INDESIT company

Model type:
WIXL105EX

Commercial code:
F030586

1140960 Exploded views

N1040319FIG1

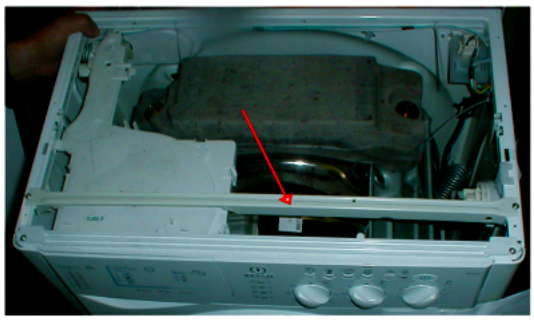
n1040319: Elimination of metal bar on INDESIT cabinets.

From serial no. 40223.0001 Indesit EVOII Washing Machines produced in the Comunanza - Brembate factory have been

equipped with a wooden reinforcing strip on the top, whereas the metal bar on the cabinet has been eliminated.
The modified tops have the same Service code as premodification items (096937, 097617, 098440, 099929 and 097806).
When using the new top on a premodification appliance the metal bar (see N1040319FIG1) must be removed, whereas the old top can be used in place of the new one without any modification.
The new top can be used in place of the old one and vice versa; the Service code remains the same.

n1040381: Drain pump with bayonet-style filter - front Loading Brembate

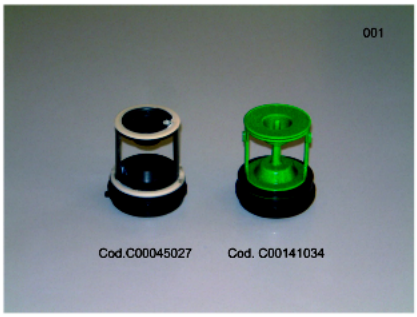
From serial no. 50720.0001 a new drain pump with bayonet-style filter has been installed on all front loading washing machines manufactured in Brembate.

New parts:
C00119307 - Drain pump
C00141034 - Pump filter kit

Premodification parts:
C00092264 - Drain pump
C00045027 - Pump filter kit

The new parts can be used instead of premodification ones.
